## Engineering Bulletin – Lyric 09 Revision 1

### Lyric 09 All-In-One

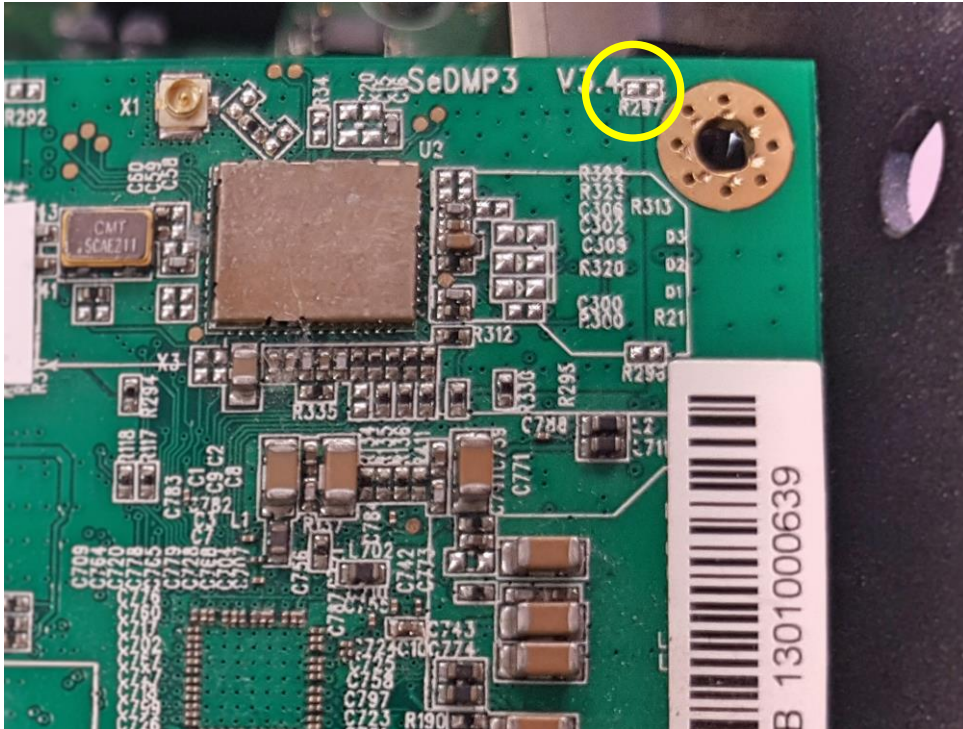
- Change R297 from DNF to 0R0 0402 (<http://uk.farnell.com/walsin/wr04x000-ptl/resistor-thick-film-0r-50v-0402/dp/2502491>)

- Change R028 from 470R 0603 to 0R0 to 0603 (<http://uk.farnell.com/yageo/rc0603fr-070r/res-thick-film-0r-1-0-1w-0603/dp/2309106>)
